September 19, 1988

SUBJECT: ISSUANCE OF AMENDMENT NOS. 170, 170, and 167 TO FACILITY OPERATING
LICENSES DPR-38, DPR-47, and DPR-55 - OCONEE NUCLEAR STATION,
UNITS 1, 2, AND 3 (TACS 68351/68352/68353)

SAFETY EVALUATION BY THE OFFICE OF NUCLEAR REACTOR REGULATION
RELATED TO AMENDMENT NO. 170 TO FACILITY OPERATING LICENSE DPR-38
AMENDMENT NO. 170 TO FACILITY OPERATING LICENSE DPR-47
AMENDMENT NO. 167 TO FACILITY OPERATING LICENSE DPR-55
DUKE POWER COMPANY
OCONEE NUCLEAR STATION, UNITS 1, 2 AND 3
DOCKET NOS. 50-269, 50-270 AND 50-287

OPERATIONAL POWER
IMBALANCE ENVELOPE
FROM 0 EFPD TO EOC UNIT 1
OCONEE NUCLEAR STATION

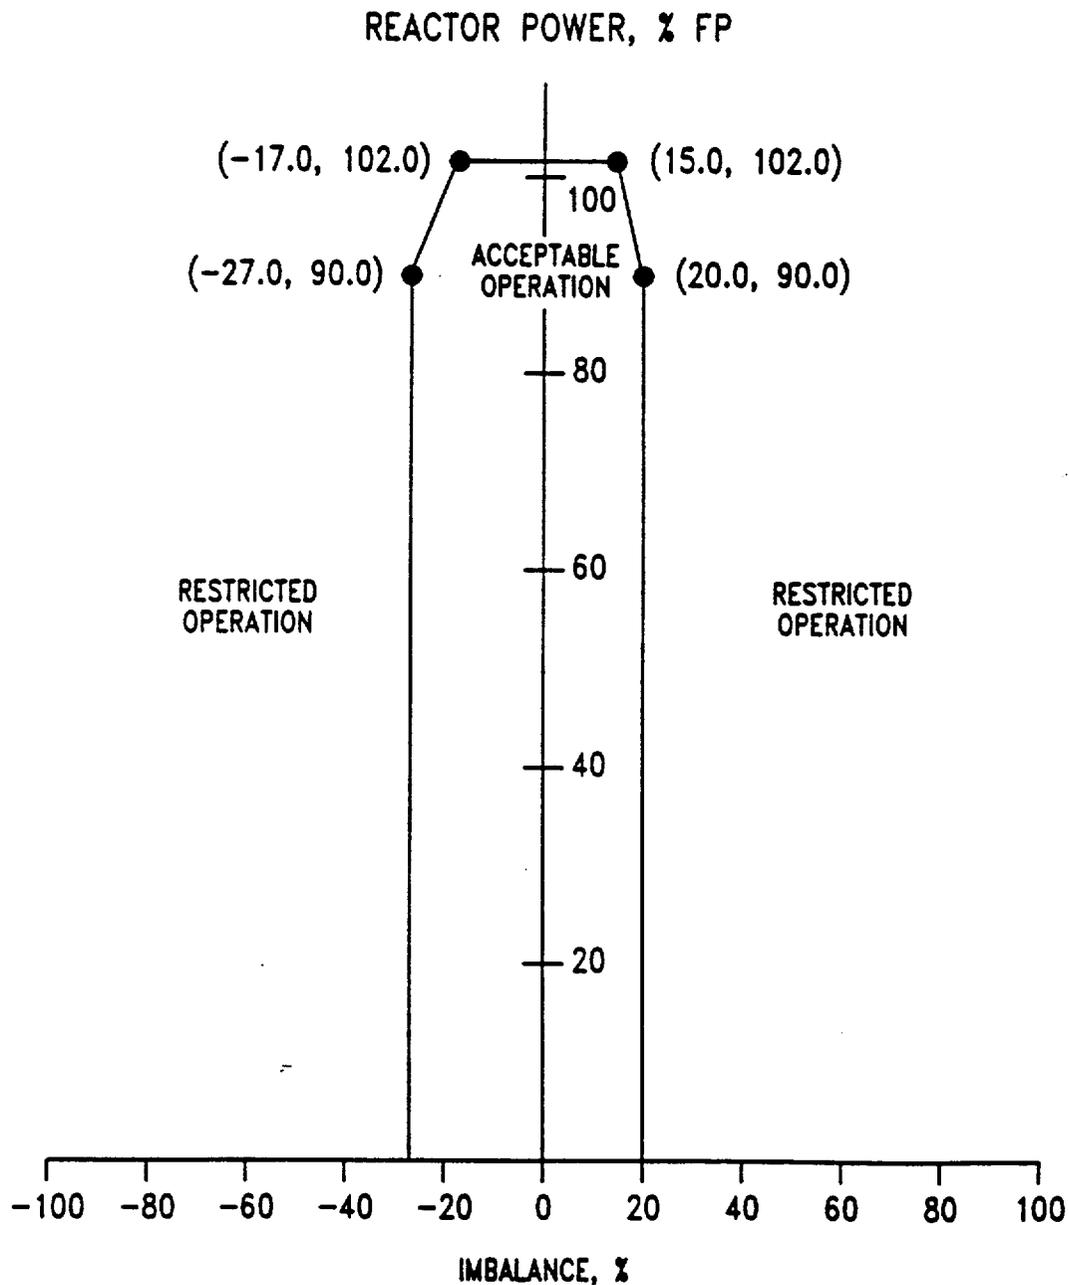
- (5) Pages 3.5-24, -25, -26. Figures 3.5.2-20, -11, -12, "Operational Power Imbalance Envelope," have been updated to provide an envelope for all 3 Oconee units. These updated limits are acceptable since they are derived from analyses performed using approved methods and have been appropriately considered in the safety analyses.
